# **BOUNTIFUL/ WOODS CROSS – 5<sup>th</sup> SOUTH PCE PLUME**

**Operable Unit 2  
Source Area Soils and Groundwater  
Superfund Site  
EPA ID # UT001119296**

**Value Engineering Study  
For  
U.S. Environmental Protection Agency  
Regional office in Denver, Colorado**

Study Date: June 11 - 15, 2007  
Final Report  
July 31, 2007

## VALUE ENGINEERING RECOMMENDATION # 5

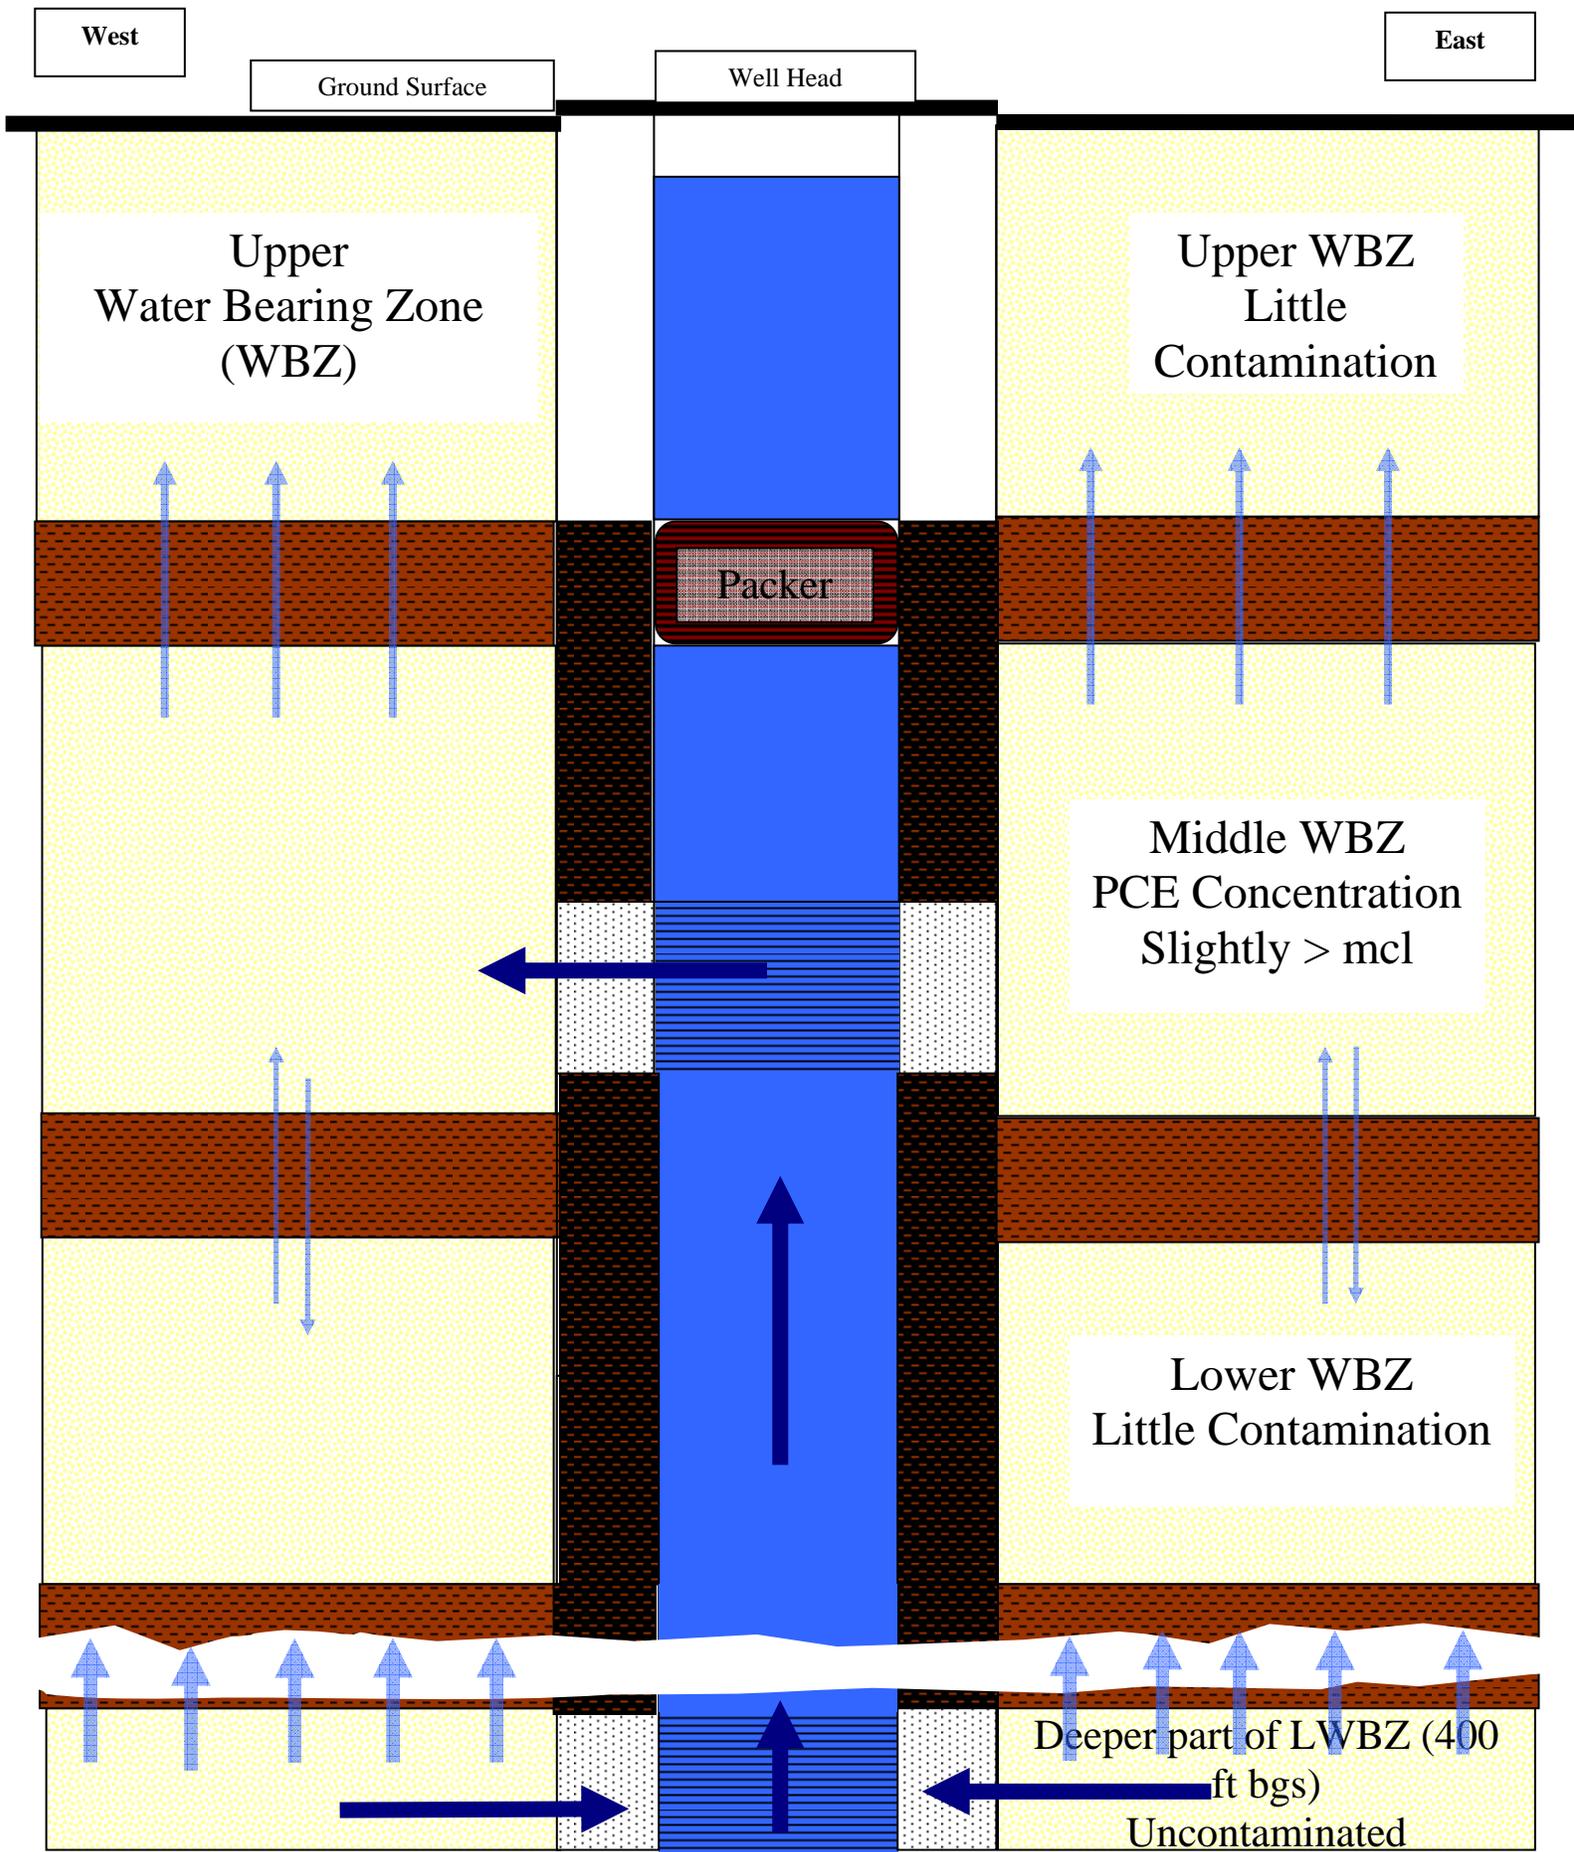
Investigate using Passive Conduit Wells strategically placed near the distal end of the plume for diffuse plume concentration management to meet 5 ppb PCE and Utah non-degradation criteria for an acceptable remedy

Consider installing passive conduit wells designed to conduct water locally from deeper, clean Water Bearing Zone(s) (WBZ) upward into the middle WBZ by natural, existing potentiometric head differences between deep confined zones and middle WBZ (i.e. "artesian" flow).
